RE: Fire Engineering Statement of Suitability | Plasser Australia - Paint Shop Alterations | 25 Kurrajong Road, North St Marys

FIRE ENGINEERING | STATEMENT OF SUITABILITY OF DESIGN

CERTIFICATE NO. :	F200883_SOS_FINAL
PROPERTY DETAILS:	Plasser Australia - Paint Shop Alterations, 25 Kurrajong Road, North St Marys
CLIENT :	Group GSA
DATE :	17 September 2018

Figure 2: Proposed New Paint Workshop Layout

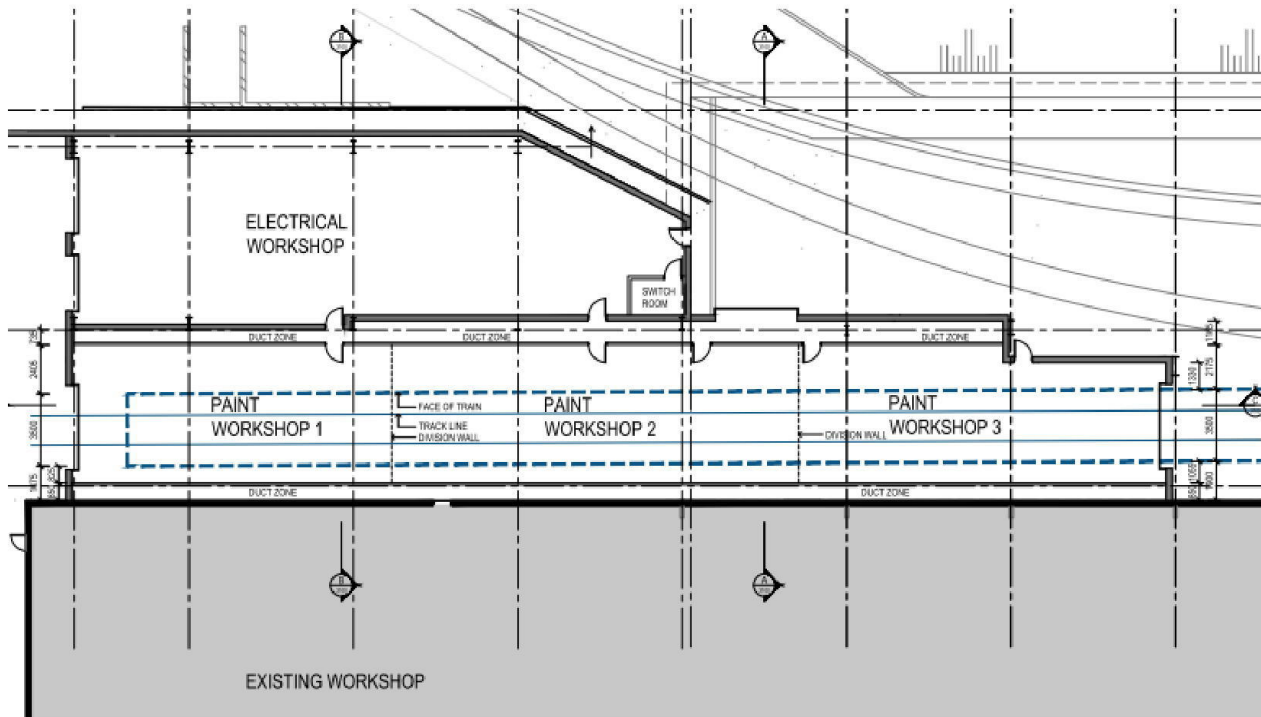
It can be seen that the extension of the paint workshop encroaches into the covered work area previously assessed in the FER.

Figure 3: Scope of FER (20028_FER_03)

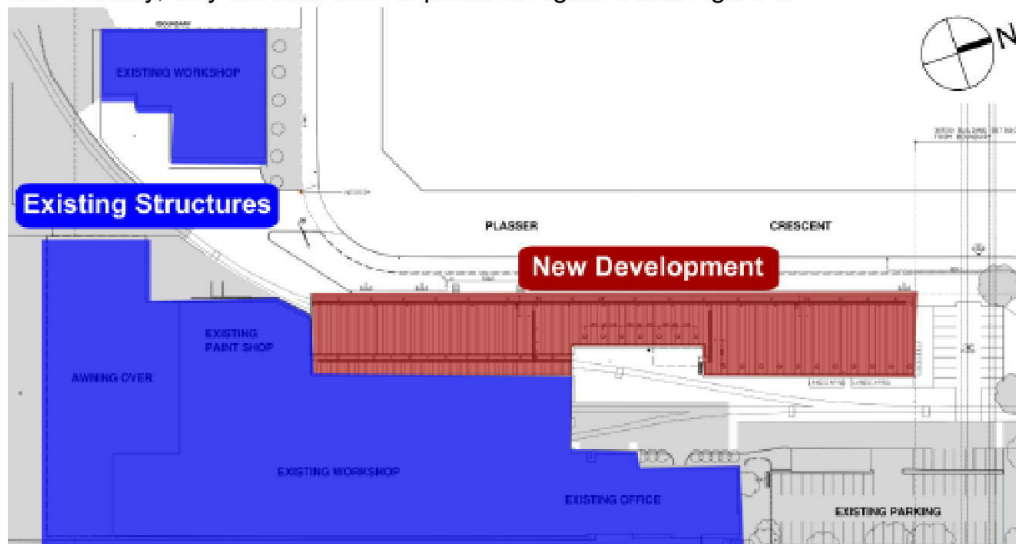
The fire engineering analysis undertaken within the existing FER (20028_FER_03) does not address the entire facility, only the extension depicted in Figure 3 and Figure 4.
